CHANGE ORDER

CO No.
03

Project Name: Hosmer & Cunniff Elementary Schools

Change Order #03
11/11/2020

HPR-005

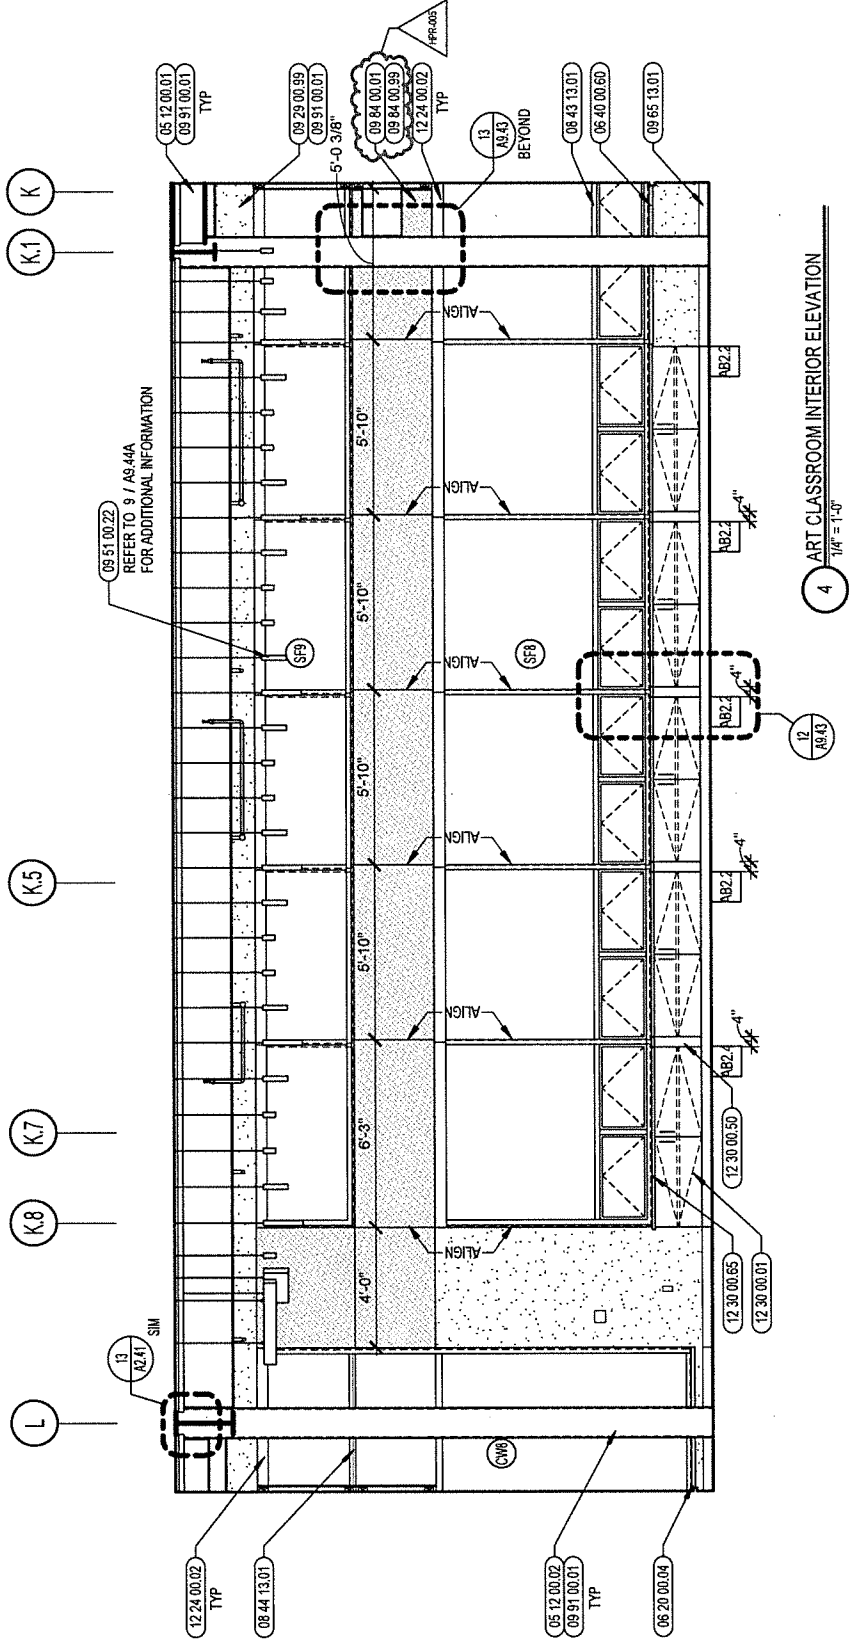
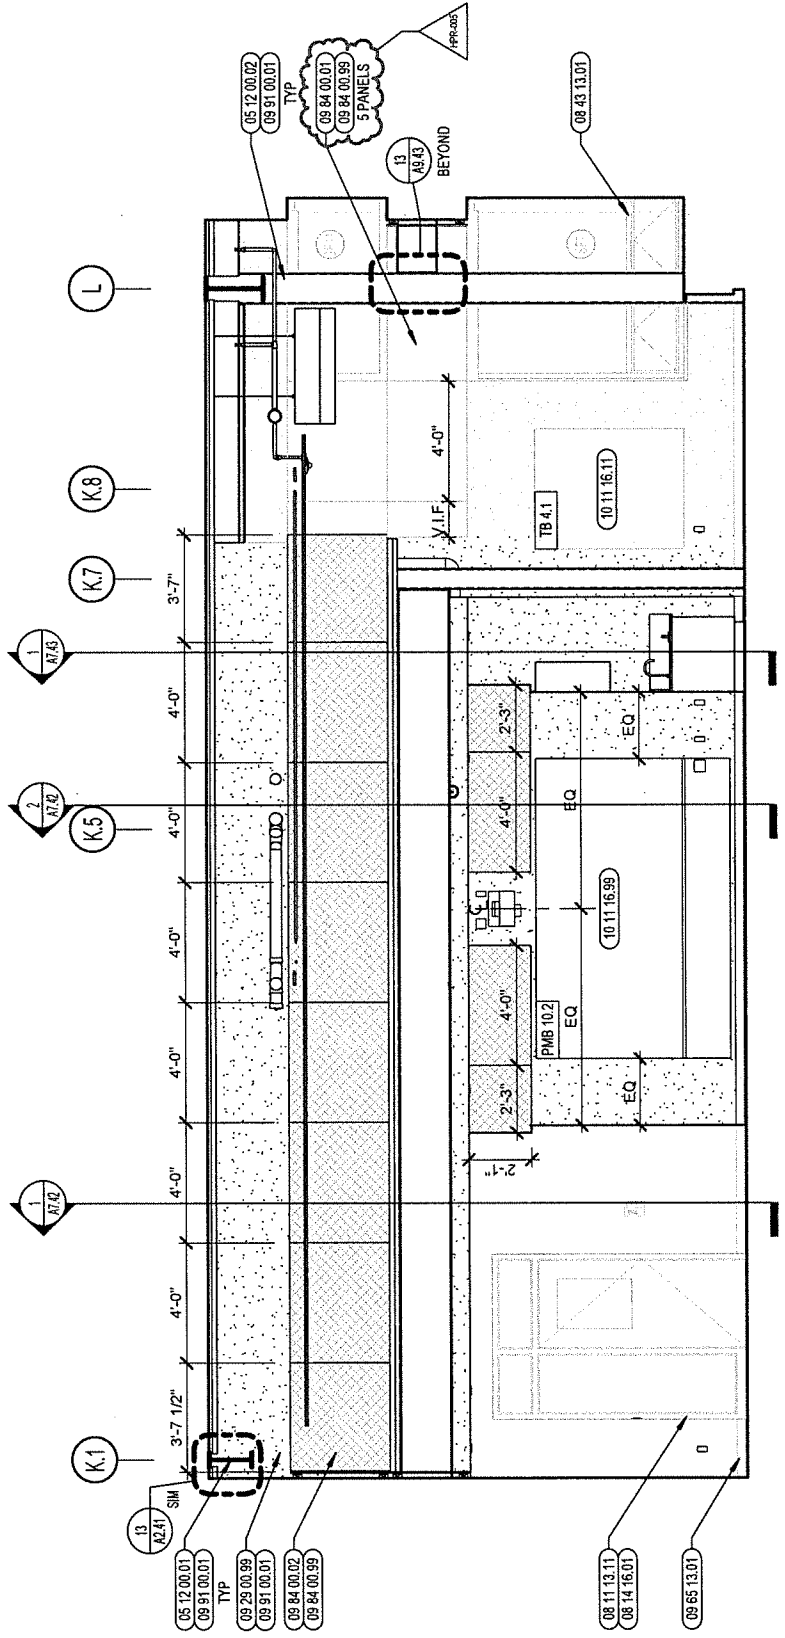
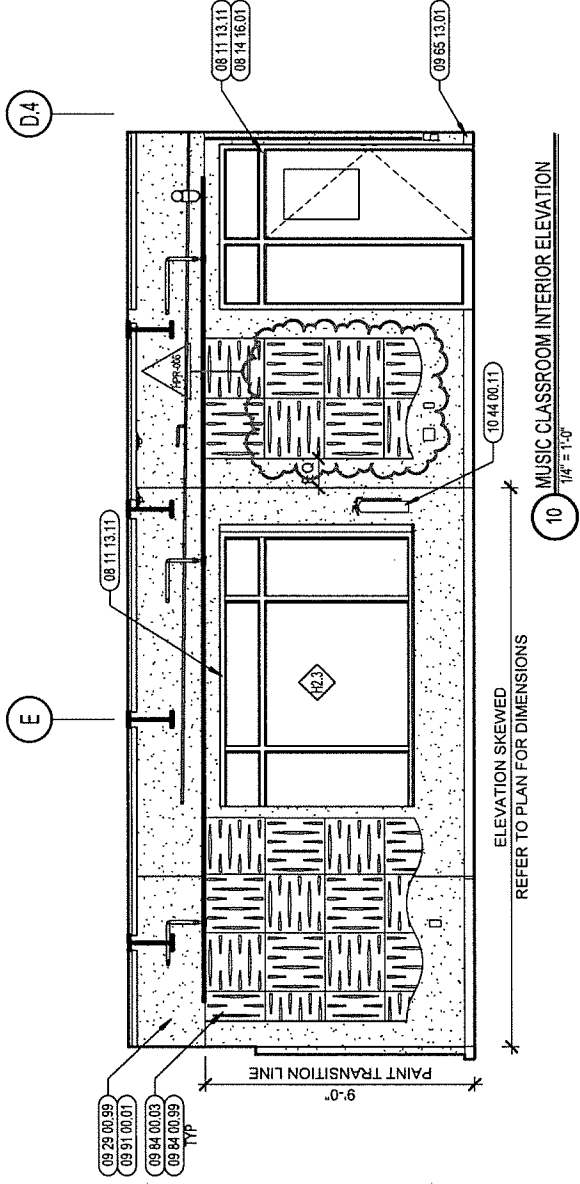
Hosmer PR-005 is a no cost change

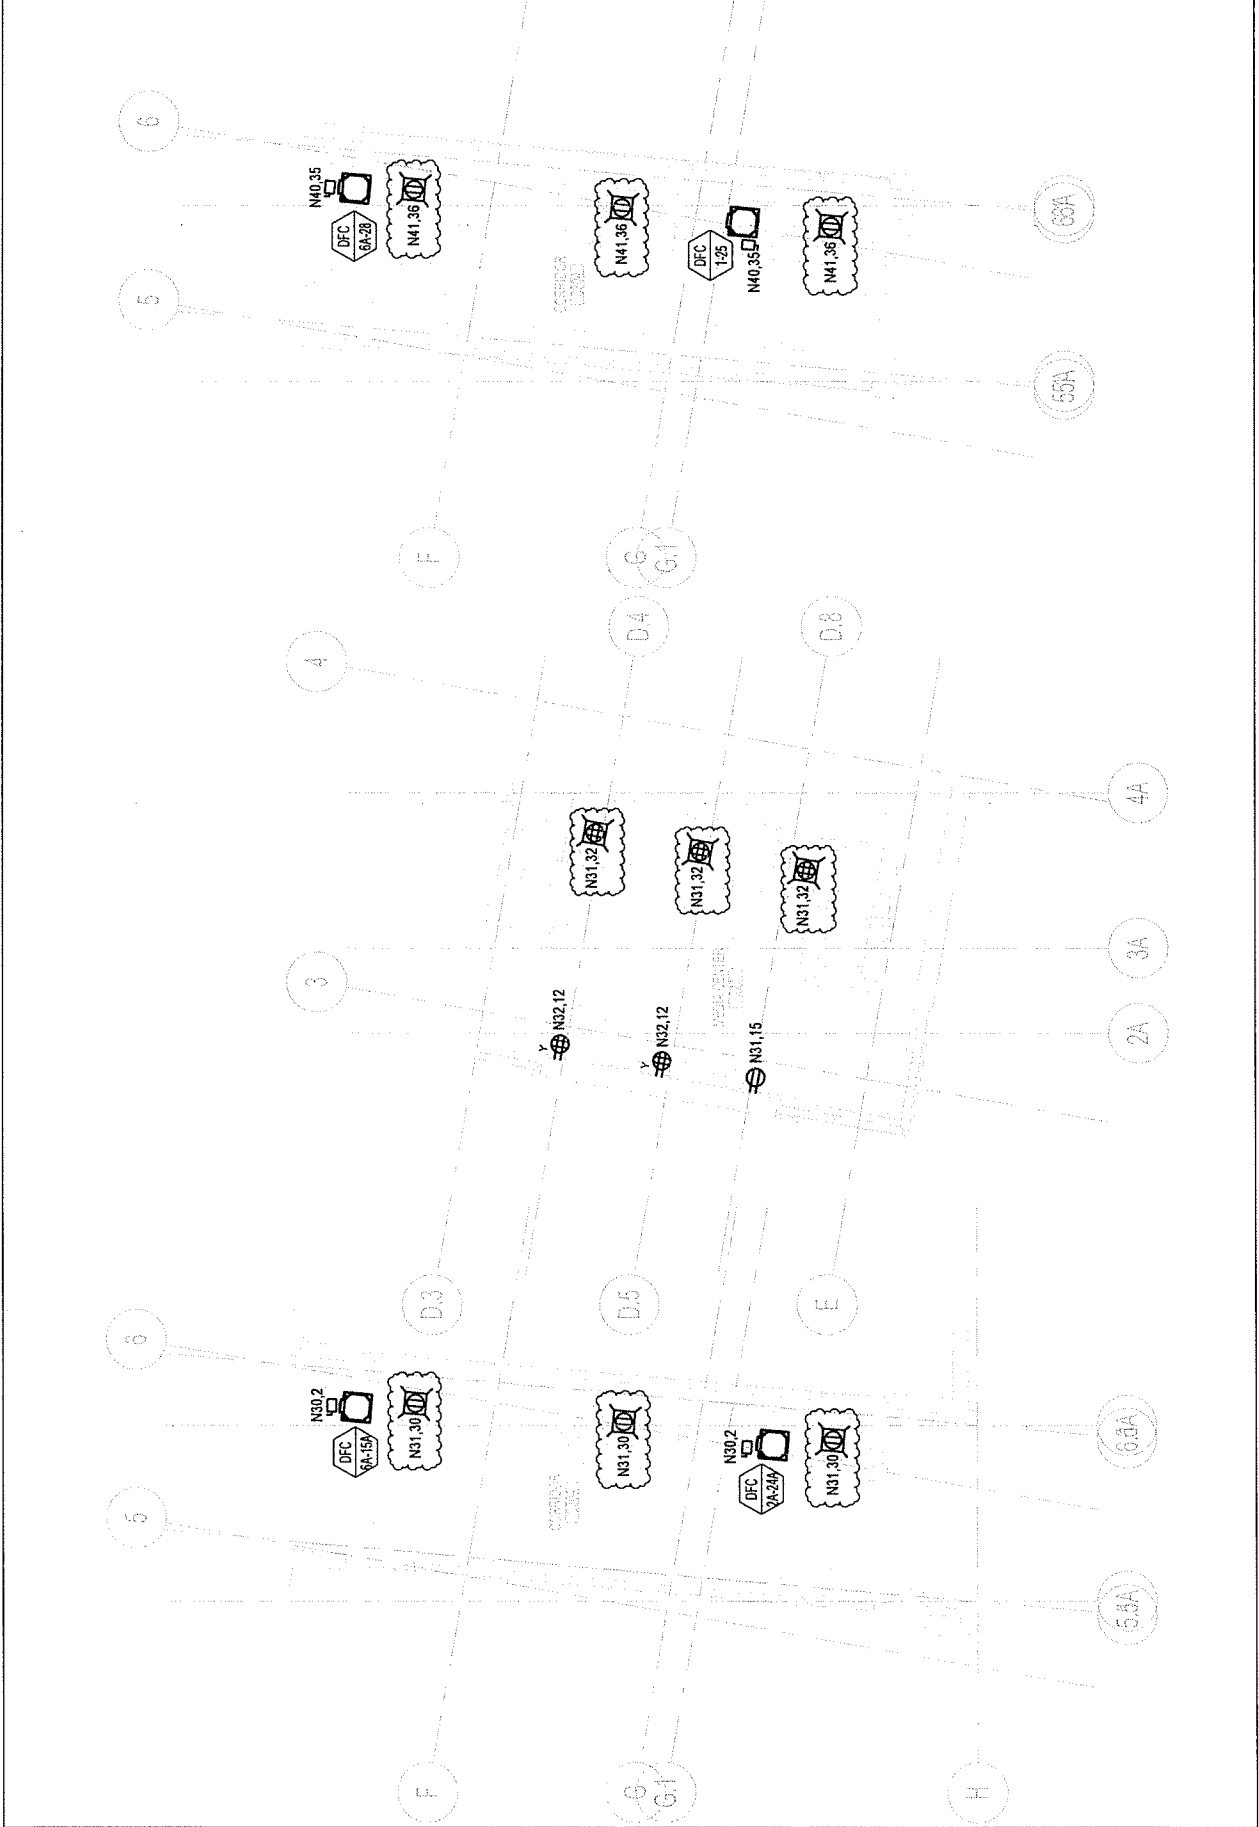
Description: Refer to the following sketches for locations where power, receptacles, and/or conduit have been added to facilitate electronic device usage within the larger group spaces.

HRFI-142

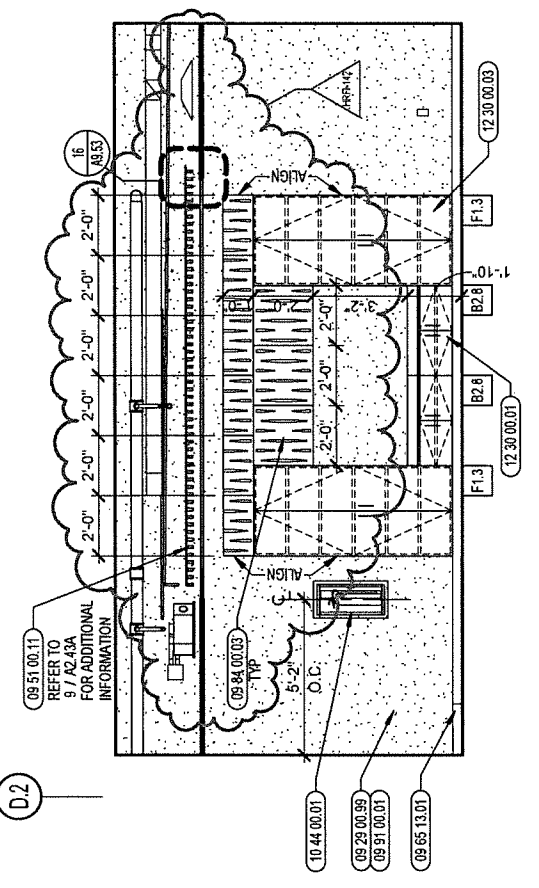
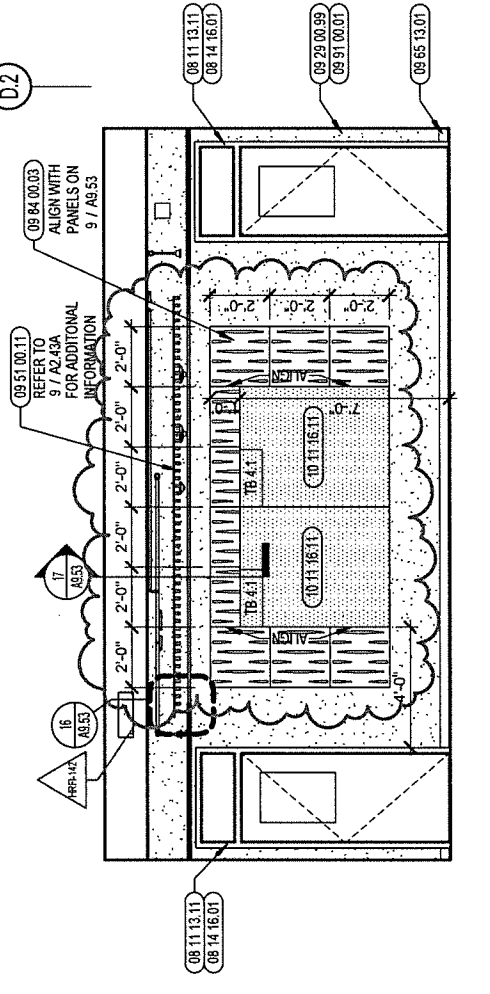
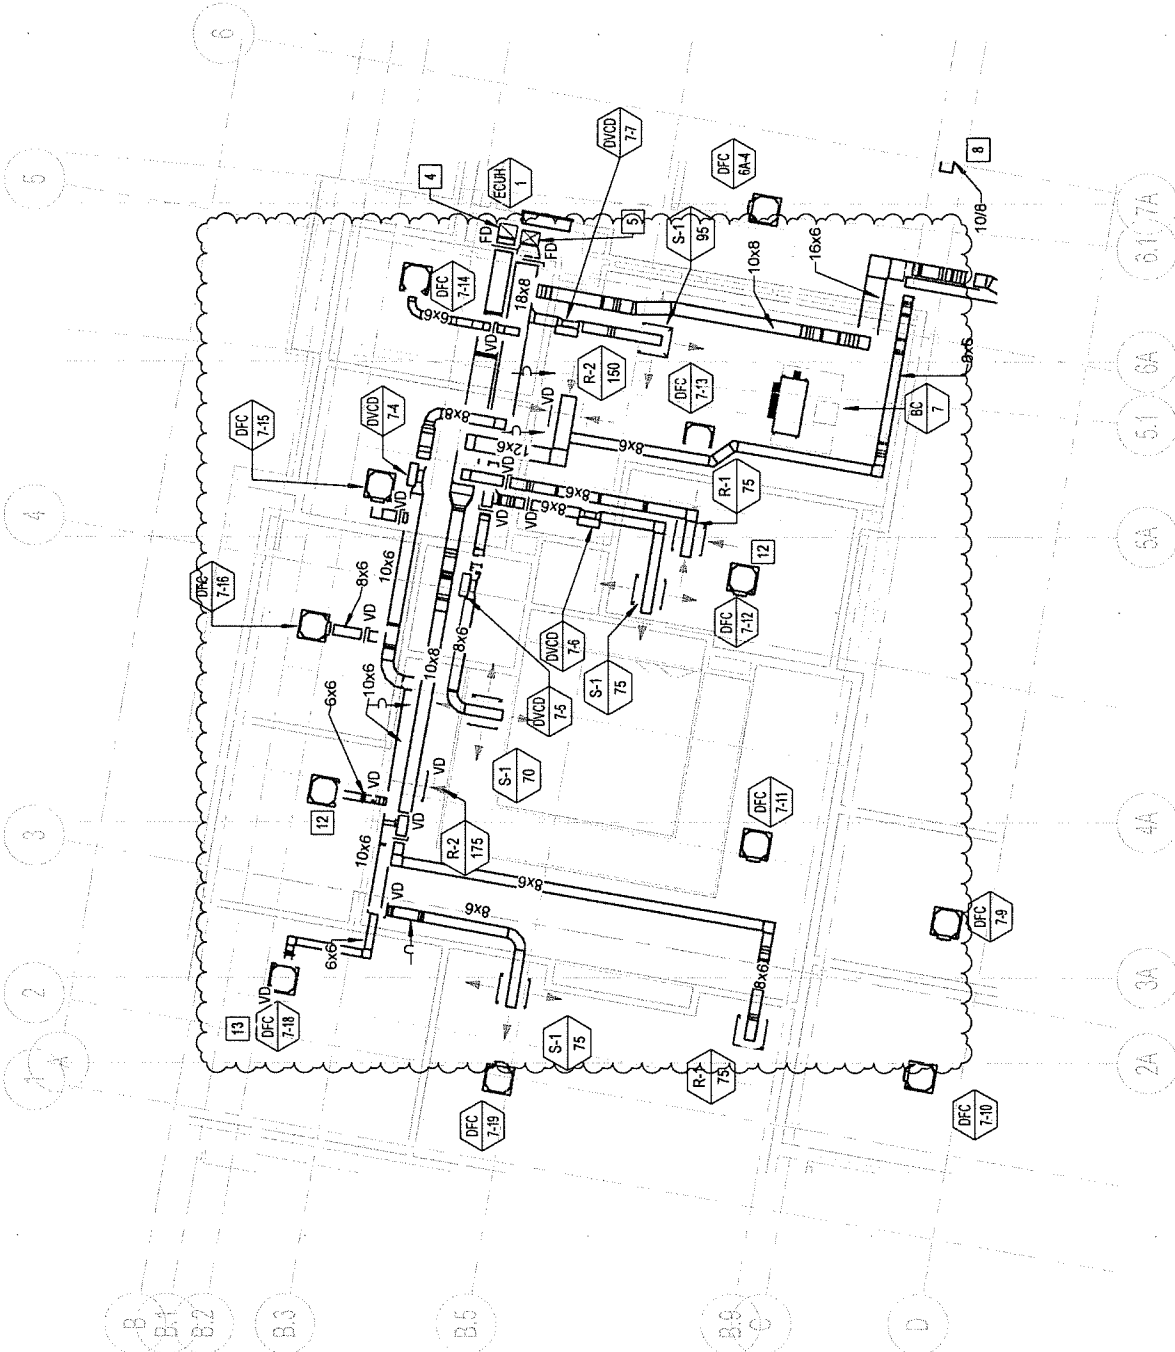
Question from Matt Fitzgerald (Brait Builders Corporation) at 03:53 PM on 09/18/2020

Refer to the following sketches for ceiling height modifications and mechanical layout modifications to resolve the identified conflicts.
